Intel386™ EX Embedded Processor

Specification Update

July 1998

Order Number: 272873-009

1. Watchdog Timer (WDT) Bus Monitor Failure During Bus Pipeline Operation

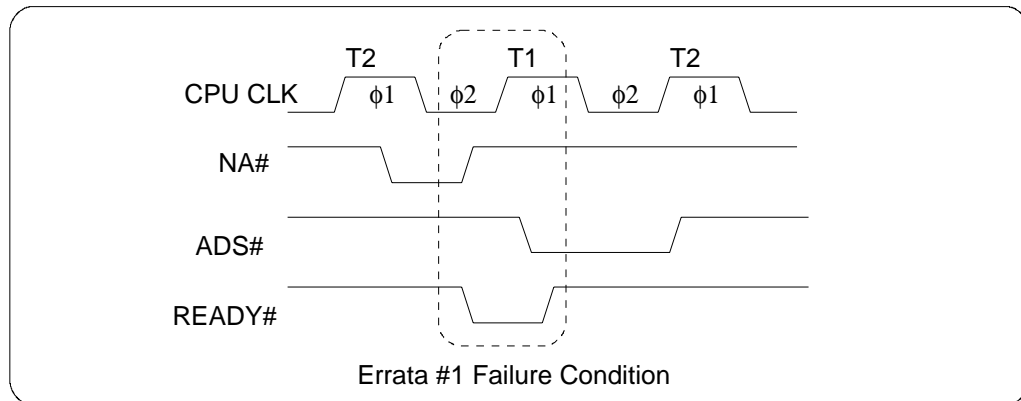
Problem: The errata applies to the WDT unit when using the Bus Monitor Mode and Bus Pipeline operation. If a pipelined bus cycle is requested at the same time the current bus cycle is completed, the WDT down counter is not reloaded or stopped. This condition means that the WDT could time-out and erroneously report a system failure. The waveform below shows the errant condition.

The errata condition is caused by the system generating READY# immediately after NA# has been requested, and a T1 cycle is generated (rather than a T2P cycle). Essentially, the system is requesting a pipelined access, but does not need it because READY# has been returned. Such a condition is not typically expected when using the pipeline feature.

Implication: Applications that use the bus monitor mode of the WDT need to be aware of this condition. If bus pipelining is not used, the errata can be ignored. If bus pipelining is used, look to the workaround description below to ensure the errata condition is avoided.

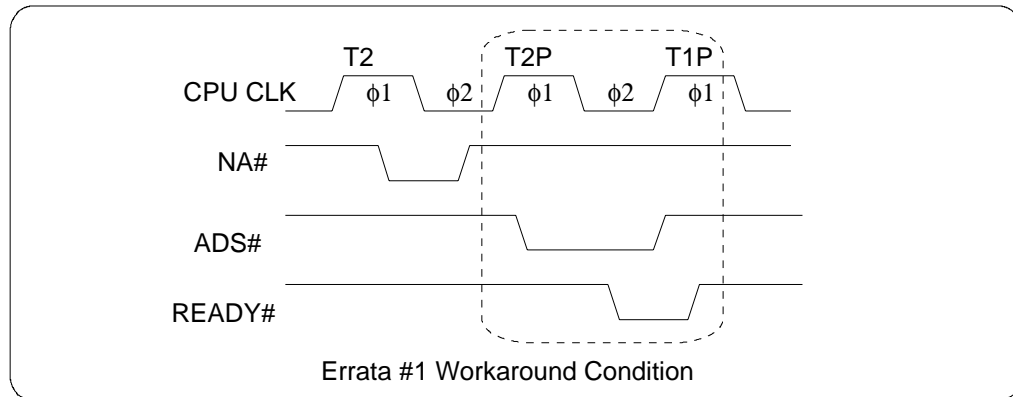
Workaround: Ensure that READY# is not generated after a pipelined bus operation is requested. See the example waveform below.

30. HLDA Inactive To HOLD Active Arbitration Could Improperly Float The Bus

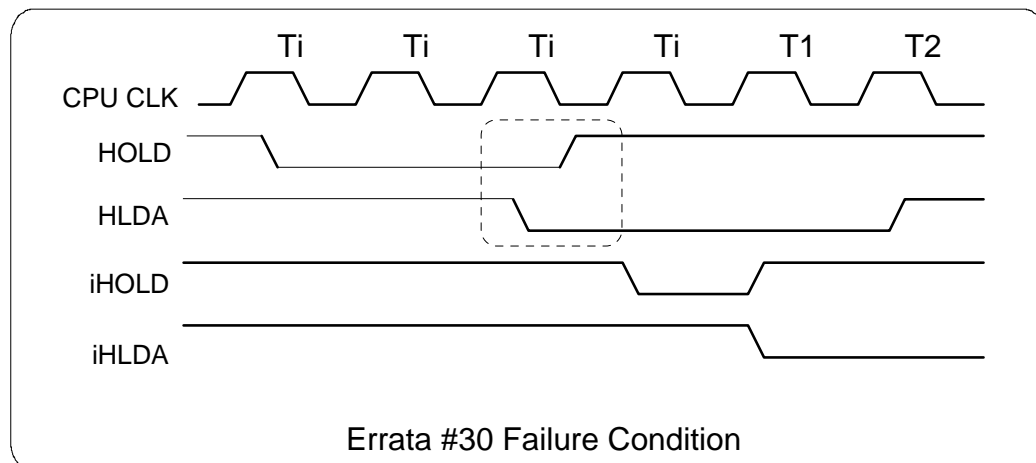
Problem: In a HOLD/HLDA cycle the HOLD signal must not be re-asserted until after HLDA is returned inactive. If, however, HOLD is asserted in the same T-state that HLDA goes inactive a problem may occur where the bus arbiter relinquishes control to the core and at the same time floats the bus by asserting the HLDA pin. The following waveform shows the conditions that cause this error. The signals iHOLD and iHLDA are internal signals and represent the HOLD input to the core and the HLDA output from the core (equivalent to the HOLD and HLDA signals on a Intel386™ SX processor). In this diagram a T1 occurs because a request was pending by the core during the previous HOLD cycle. One T-state after the arbiter releases the bus (HLDA = 0) it removes its iHOLD, and then the core removes iHLDA. As soon as the iHLDA is released, the T1 state starts. However, because of the timing of the next HOLD request, the bus arbiter re-asserts iHOLD and HLDA even though the core has not asserted iHLDA. The result is that the core continues to run its bus cycle and, at the same time, the bus arbiter has floated the external bus. It is also possible for the following to occur when HOLD/HLDA arbitration is at issue: HOLD is driven active during the T1 or Tw of a valid bus cycle. The processor begins the next bus cycle and generates HLDA. HLDA is active for only one T-state. ADS# is extended through the bus cycle. The alternate bus master sees the HLDA and performs its bus activity. HOLD is then driven inactive and the bus is returned to the Intel386™ EX Processor. At this point there is bus contention.

It is also possible for the following to occur when HOLD/HLDA arbitration is an issue: HOLD is driven active during the T1 or Tw of a valid bus cycle. The processor begins the next bus cycle and generates HLDA. HLDA is active for only one T-state. ADS# is extended through the bus cycle. The alternate bus master sees the HLDA and performs its bus activity. HOLD is then driven inactive and the bus is returned to the Intel386™ EX Processor. At this point there is bus contention.

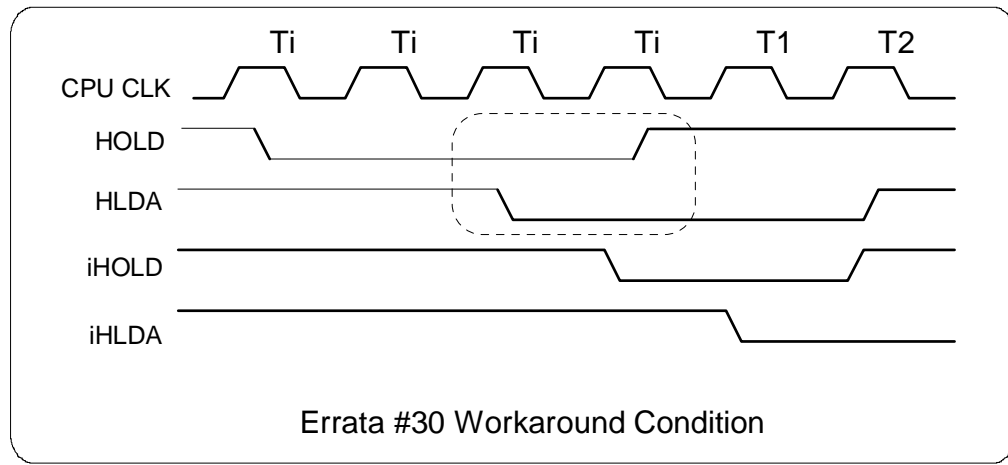
Workaround: Synchronize the external HOLD request such that it does not go active until at least one T-state after HLDA is inactive. See the following example waveform.

Figure 3. HOLD with Short REFRESH Interval

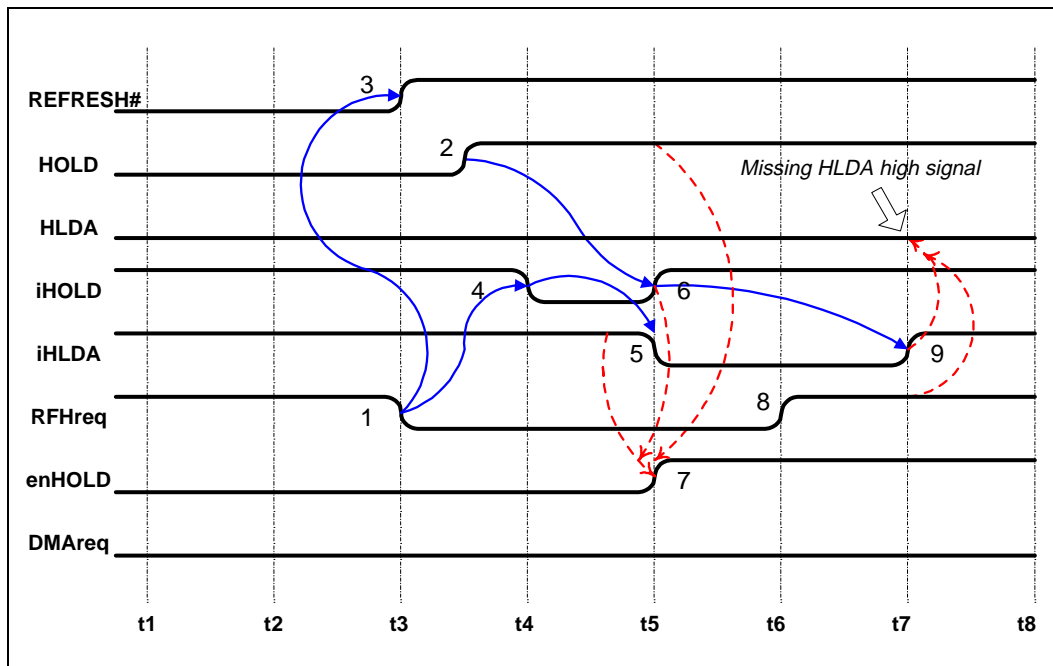
Figure 3 shows Condition #1a where an external HOLD and refresh request conflict can occur. The table below describes each signal name used:

Figure 4. Quick HOLD Assert and Deassert with Slow REFRESH Interval

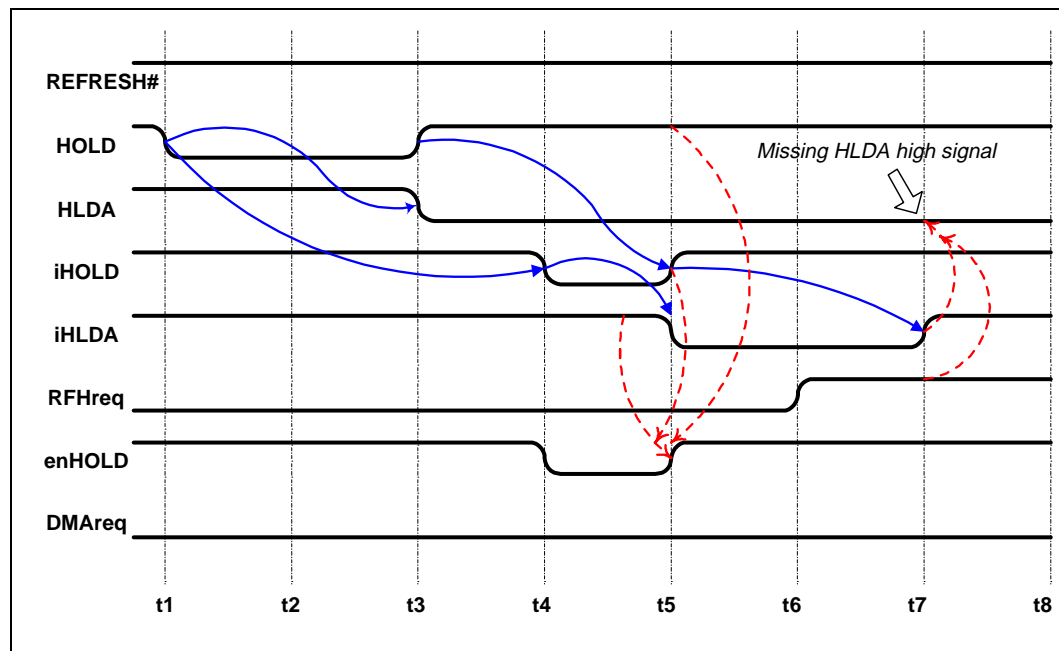
- b. HOLD is removed and reasserted within one bus cycle. Refer to Figure 4. This condition will cause the problematic window with fast iHOLD deassertion (t4) and assertion (t5). Note that if HOLD is deasserted because of pending REFRESH and reasserted again within one bus cycle, the problem will not occur since the iHOLD signal is never deasserted due to refresh. The reassertion of the HOLD would then be serviced upon completion of the refresh.

Figure 5. DMA, HOLD and REFRESH with Normal Interval

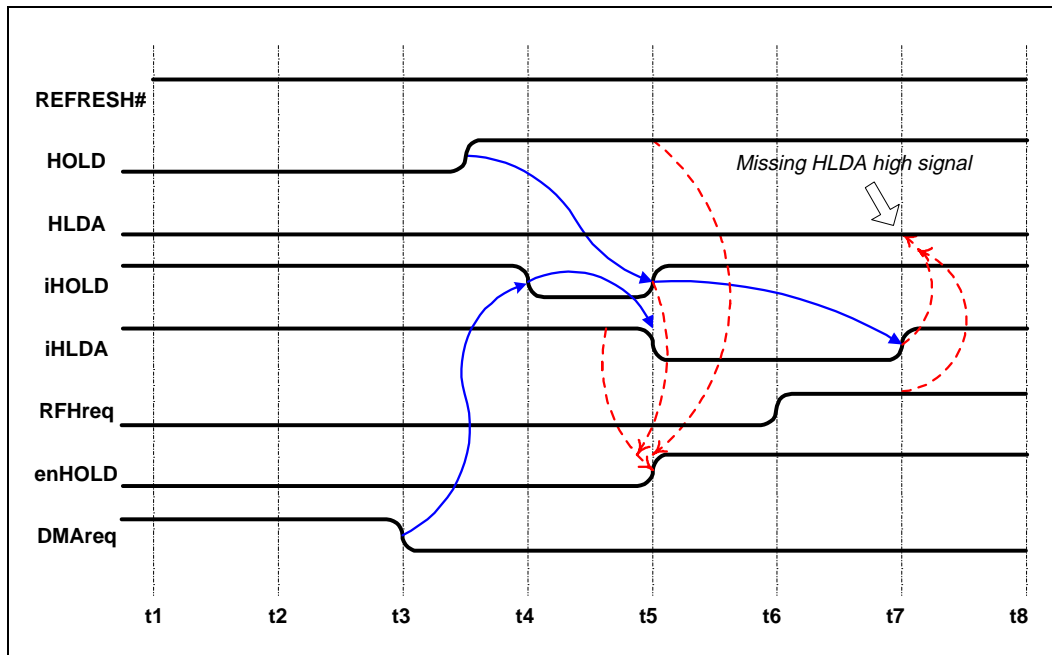
For the errata to occur, HOLD must be asserted asynchronously at any cycle such as in an idle cycle. Refer to Figure 5. Termination of DMAREQ at time t3 with assertion of HOLD at time t4 creates the problematic window. If there is a refresh request at time t6, the HLDA is blocked and will not go active at time t7. If HOLD is synchronized at the beginning of a *new* valid bus cycle (except for REFRESH), HLDA will always be asserted since the problematic window will not occur.

11. 272485-002, Section 6.3.6, Page 6-30, Figure 6-12.

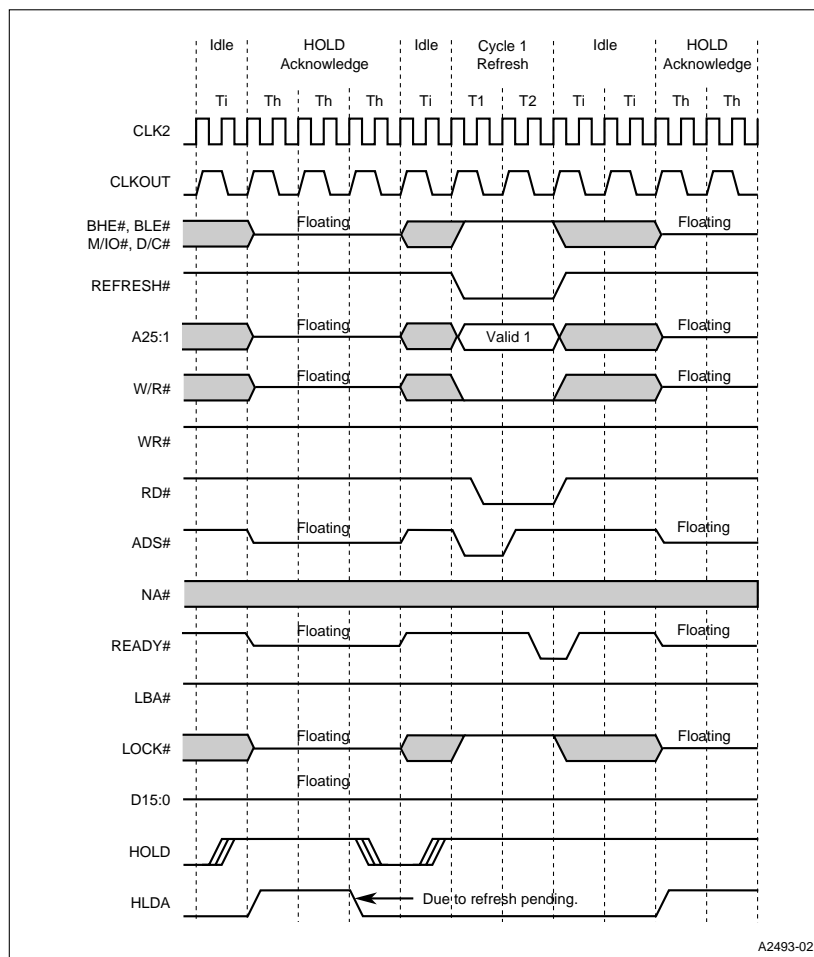
Issue: Modified the ADS# and READY# waveforms to indicate floating. The corrected figure is shown below.

Figure 11. Transmit Data by Polling

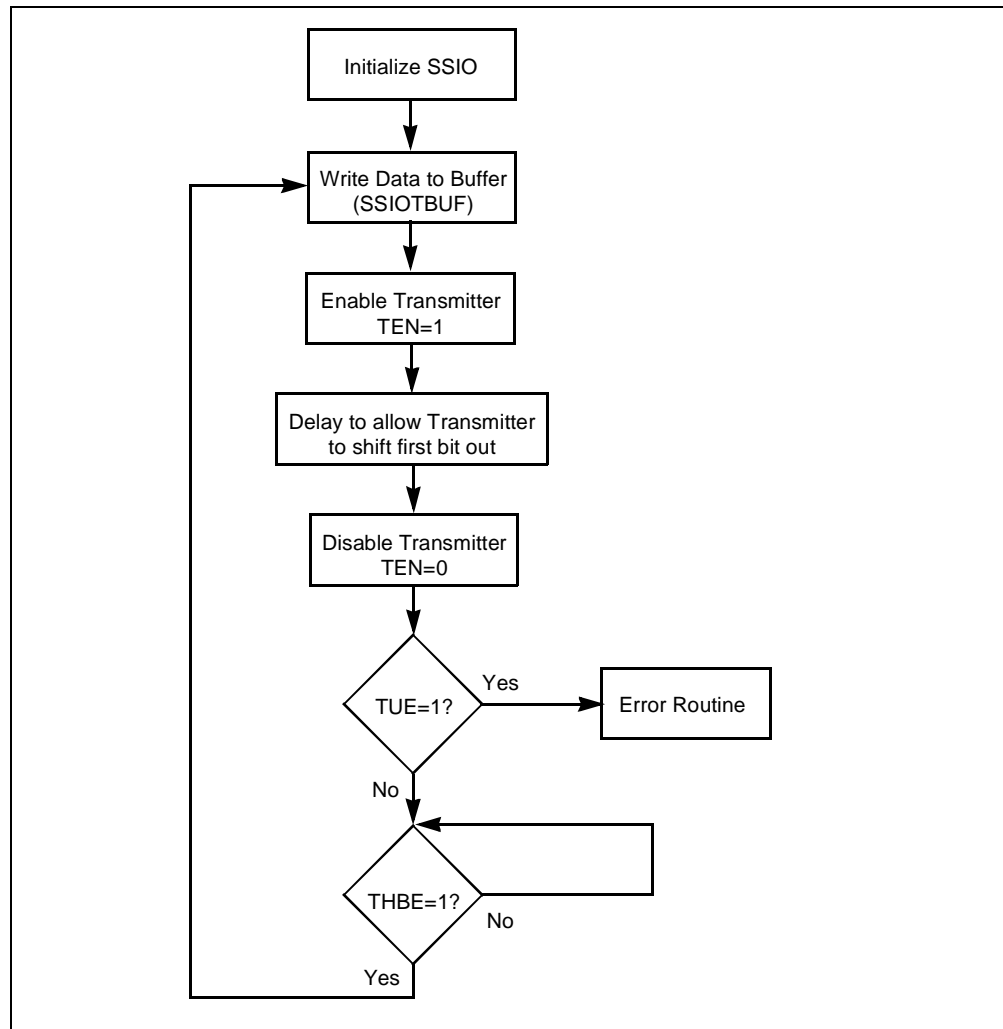
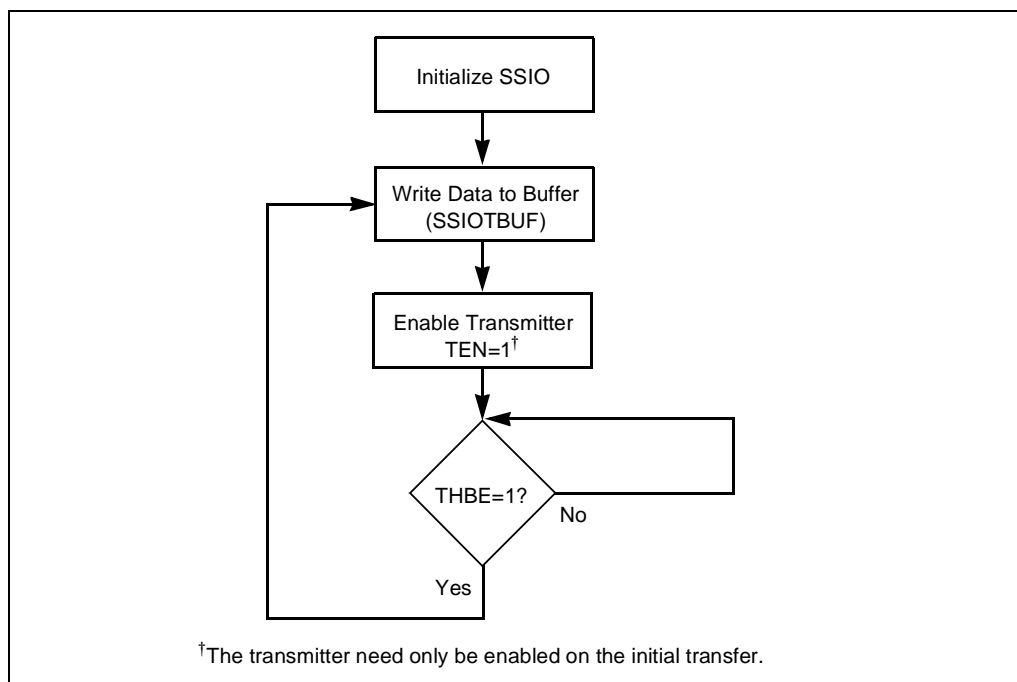
Issue: Replace figure 13-8 with Figures 13-8a and 13-8b as shown below.
